Access Compliance Report Public Rights-of-Way (Curb Ramps)

Main Street: ST_JUST_ST Cross Street: ST_IVES_WAY Location: NE

ADA ID: RPRK211115115603 Ramp Type: Type 4 - Parallel Initial Pass/Fail: Fail Overall Compliance: No Severity Score: 2

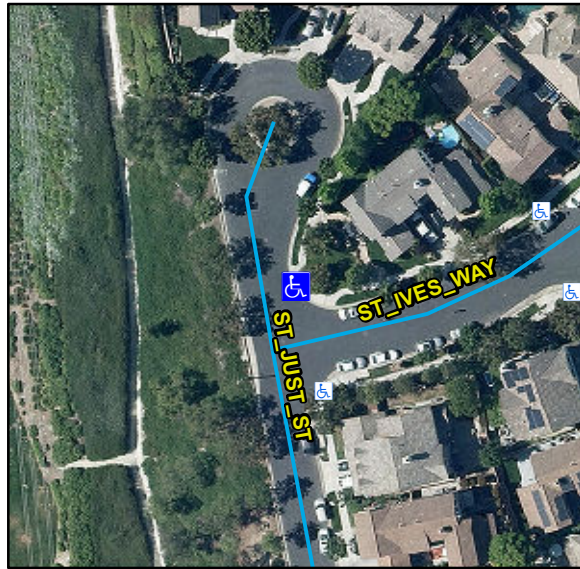
Compliance	Description	Data	Compliance	Description	Data
N/A	Ramp Length LT (in)	133	N/A	Ramp Length RT (in)	131
Yes	Ramp Width LT (in)	54	Yes	Ramp Width RT (in)	54
Yes	Ramp Run Slope LT (%)	6.8	Yes	Ramp Run Slope RT (%)	4.7
No	Ramp Cross Slope LT (%)	2.1	Yes	Ramp Cross Slope RT (%)	0.2
N/A	Landing Present	N/A	N/A	DWS Provided	N/A
N/A	Landing Length (in)	N/A	N/A	DWS Contrast	N/A
N/A	Landing Width (in)	N/A	N/A	DWS Length (in)	N/A
N/A	Landing Run Slope (%)	N/A	N/A	DWS Full Width	N/A
N/A	Landing Cross Slope (%)	N/A		DWS Offset Type	N/A
N/A	Landing Movement Obstructed?	N/A	N/A	DWS Offset Left (in)	N/A
	Landing Movement Type	N/A	N/A	DWS Offset Right (in)	N/A
N/A	Landing Shared	N/A			
N/A	Clear Space	Yes			
N/A	Clear Space To Crosswalk (in)	N/A			
N/A	Marked Crosswalk 1	No	N/A	Marked Crosswalk 2	No
	Crossing 1 Direction	W		Crossing 2 Direction	S
	Marked Crosswalk 1 Width (in)	N/A		Marked Crosswalk 2 Width (in)	N/A

Remove & Replace Curb Ramp With Two New Directional Ramps or Equivalent.
